## SIMPLEX FIFTH WHEEL FIELD CAMPAIGN NOTIFICATION

This notification is to make you aware of a field campaign that SAF-HOLLAND is undertaking to replace a spacer in the lever bar connection that could affect the timing of the fifth wheel's lock mechanism. This is **NOT** a safety related issue as this condition is evident to the driver when visually inspecting the release handle and position of the red indicator in accordance with the proper coupling procedure.

**FIGURE 1 – AFFECTED UNIT**

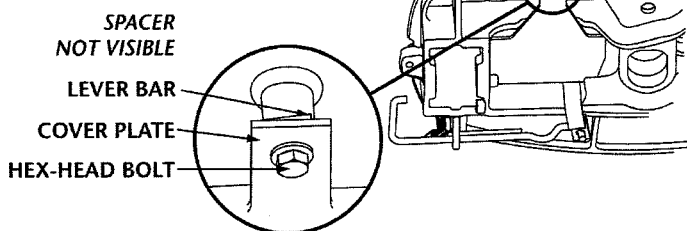
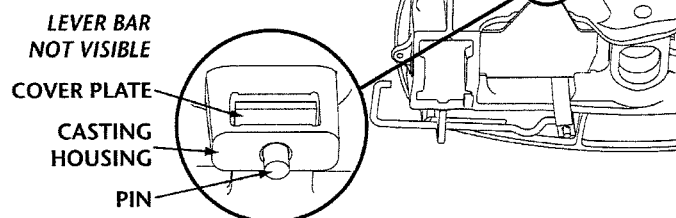
The Simplex fifth wheels that should be inspected were manufactured between January 3, 2006 and July 2, 2007. Visually inspect the cover plate/lever bar connection on the underside of the fifth wheel. The fifth wheel is **affected** if a hex-head fastener is used to secure the connection as shown in Figure 1. The fifth wheel is **unaffected** if a pin is used to secure the connection as shown in Figure 2.

If you have a fifth wheel that matches the image in Figure 1, we strongly encourage you to contact us for a repair kit(s), free of charge, at (888) 396-6501 ext 4343. Be prepared to provide: serial number of the wheel, VIN # of the vehicle, date and service. If you have any questions concerning this notification, please ask for technical assistance when you contact us.
